U.S. Department of the Interior
BUREAU OF LAND MANAGEMENT

Well Name: FULLERTON FEDERAL

Subsequent Report

Type of Action: Plug and Abandonment

Current Schematic - Version 3

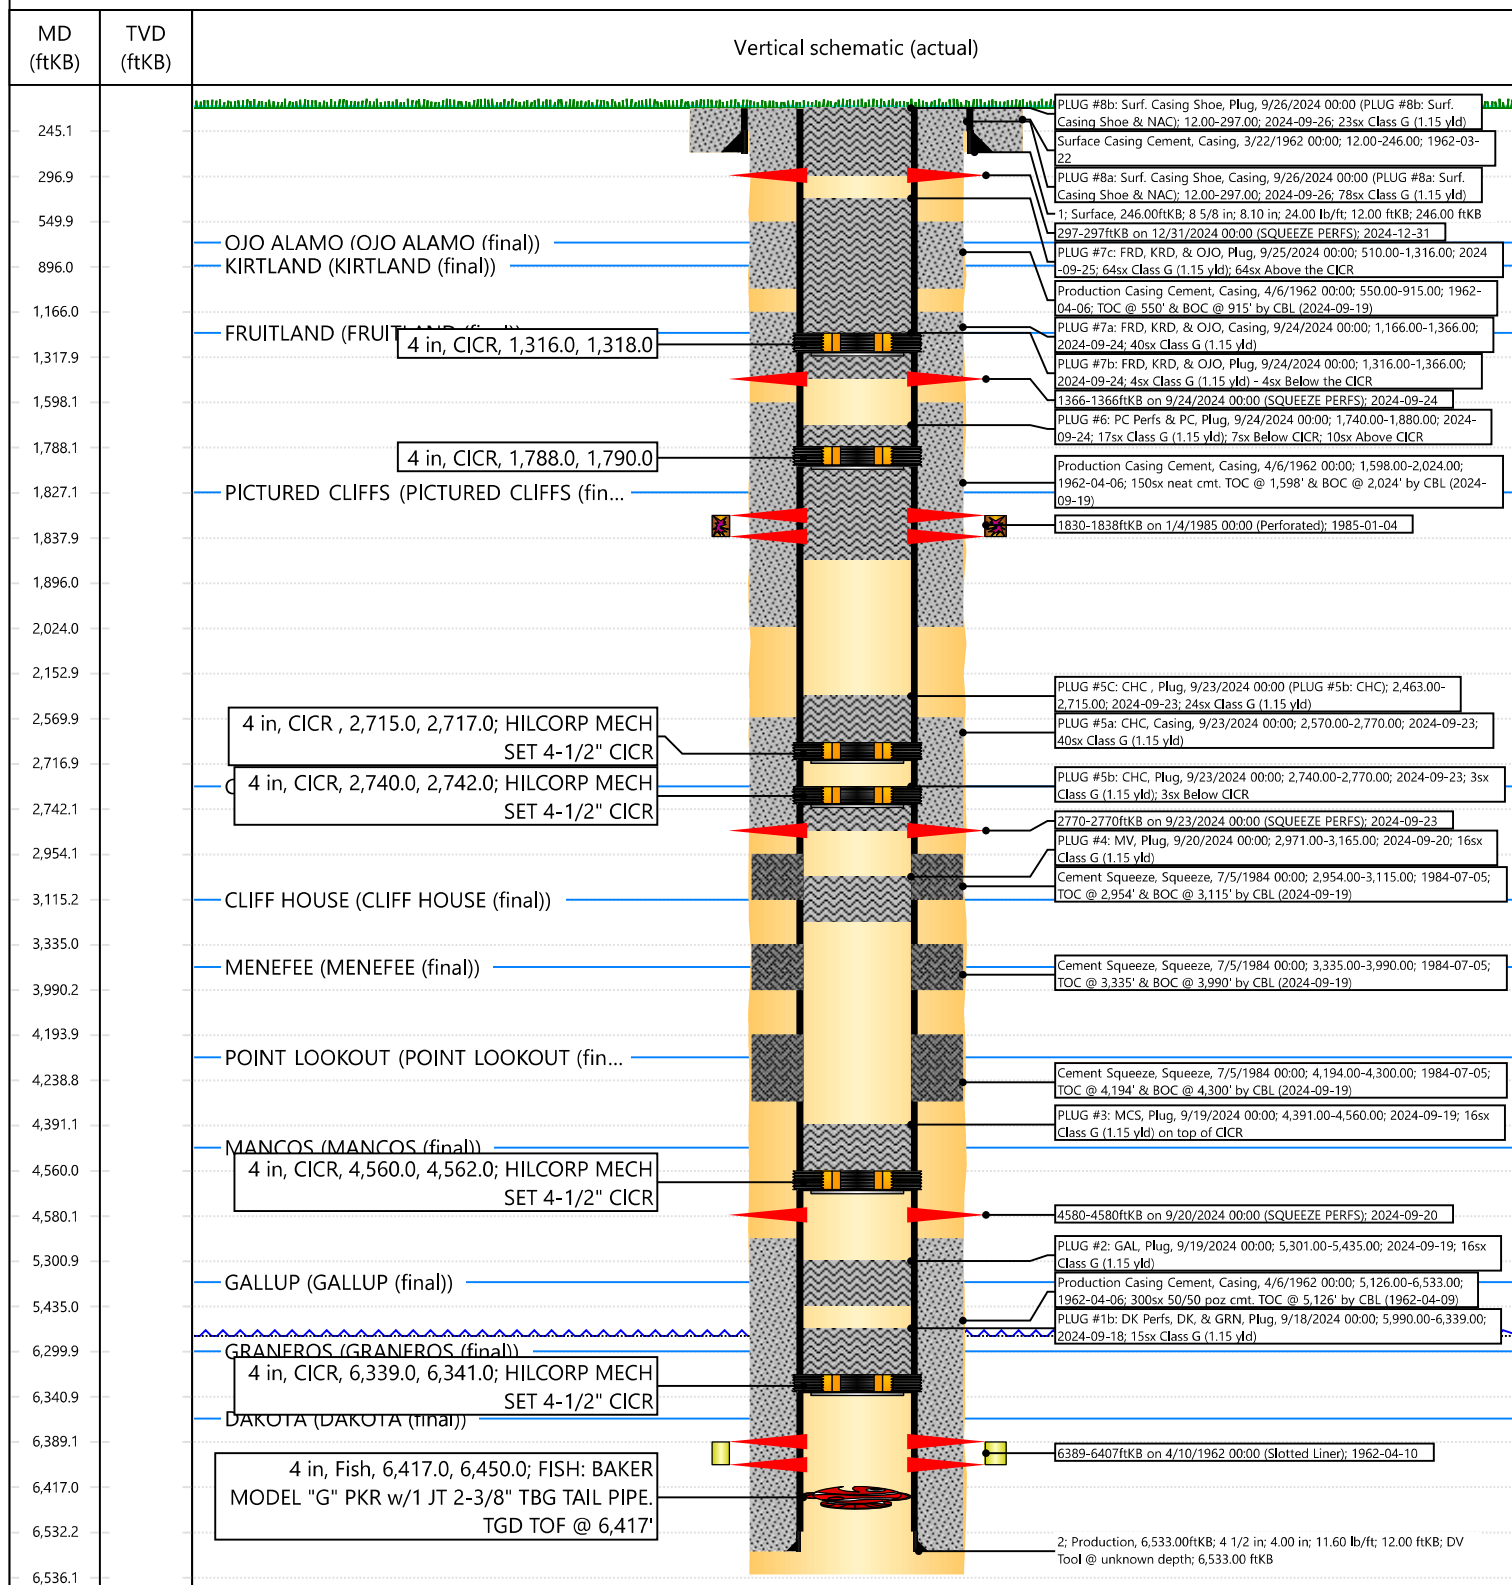
7/9/2024 – HEC ENGINEER SENT AN EMAIL TO BLM AND NMOCD REQUESTING ADJUSTMENTS TO THE APPROVED PROCEDURE BASED ON THE COAs. BLM APPROVED THE ADJUSTMENTS. NMOCD REQUESTED THAT HEC GO IN OPEN ENDED TO GET CEMENT TO FISH AND TO EXTEND PC TOP PLUG 5 TO 1877'.

Moving forward, Hilcorp received verbal approval from the NMOCD & BLM for the following adjustments to the previously approved procedure:

- **PLUG #5c: 12sx of Class G Cement (15.8 PPG, 1.15 yield); CHC Top @ 2,740':**
 - Set a 4-1/2" CICR @ 2,715'
 - Pump a 12 sack balanced cement plug inside the 4-1/2" casing (est. **TOC @ +/- 2,565'** & est. **BOC @ +/- 2,715'**). *Note cement plug lengths and volumes account for excess.
 - WOC & Tag
- All other plugs will be pumped as previously approved in the email chain below

Moving forward, Hilcorp received verbal approval from the BLM & NMOCD to make the following adjustments to the procedure:

- **PLUG #3: 52sx of Class G Cement (15.8 PPG, 1.15 yield); MCS Top @ 4,530':**
 - TIH & perforate squeeze holes @ +/- 4,580'. RIH w/ 4-1/2" CICR and set CICR @ +/- 4,560'. TIH w/ work string & sting into CICR. Establish injection.

- **PLUG #4: 12sx of Class G Cement (15.8 PPG, 1.15 yield); MV Top @ 3,115':**
 - Pump a 12 sack balanced cement plug inside the 4-1/2" casing (est. TOC @ +/- 3,015' & est. BOC @ +/- 3,165'). *Note cement plug lengths and volumes account for excess.

- **PLUG #5: 53sx of Class G Cement (15.8 PPG, 1.15 yield); CHC Top @ 2,740':**
 - TIH & perforate squeeze holes @ +/- 2,770'. RIH w/ 4-1/2" CICR and set CICR @ +/- 2,740'. TIH w/ work string & sting into CICR. Establish injection. ***Note that perfs are @ 2,770' to avoid cement stringers below that depth**

To confirm, the BLM finds the procedure appropriate.

NMOCD approves below with prior approval from the BLM

To confirm, the BLM finds the updated procedure appropriate.
